Product Support Bulletin 2011-005

SUBJECT: BAAM Workhead Cylinder Clevis Pin Upgrade Kit 98690026

MACHINE MODEL(S): Anchor Applicator BAAM

SERIAL NUMBER(S): BAAM S/N 690025 through S/N 690071

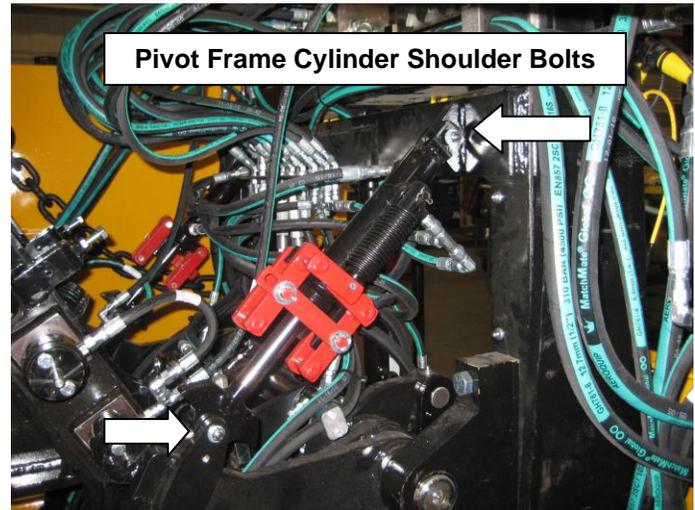
SUMMARY: A kit to upgrade the existing clevis pins on the Frame Up/Down Cylinder and the two Pivot Frame Cylinders to Grade 8 shoulder bolts is available by ordering P/N 98690026.

Switching to the shoulder bolts will reduce possible clevis pin surface wear and provide increased shear strength in these critical locations.

ACTION: Customer install would be required and LOTO procedures should be followed during installation. Allow approximately 1 hour for installation.
